Pasco County Florida REVIEWED FOR CODE COMPLIANCE Approval of these documents constitutes authority to proceed with the work but does not grant authority to violete, cancel, after or set aside any of the technical codes

HUNTERS RIDGE NEW PORT RICHEY

PLAN DATE DEEB FAMILY HOMES, LTD

# BUILDING SHEET COVE

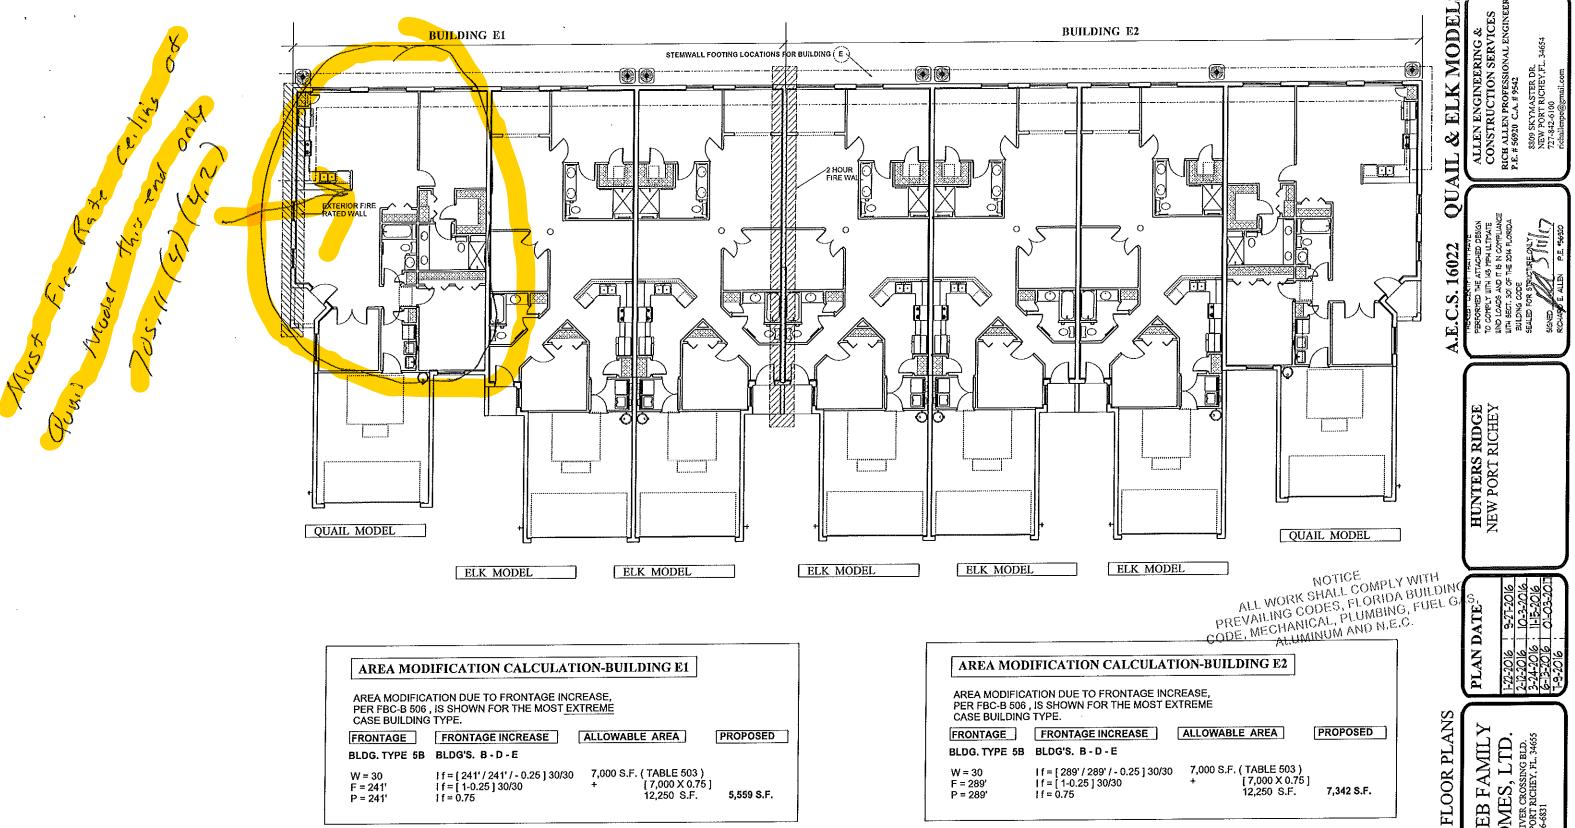
- 1. ALL BATHROOM AND BEDROOM DOORS TO BE 34" WIDE X 80" HIGH
- 2. BUILDING TYPE TO BE 5B
- 3. UL DESIGN # FOR 8" BLOCK WALL IS U905
- 4. INTERIOR FLAME / SMOKE DEVELOPMENT CLASSIFICATION FOR INTERIOR FINISHES IS CLASS - C PER TABLE 803.3
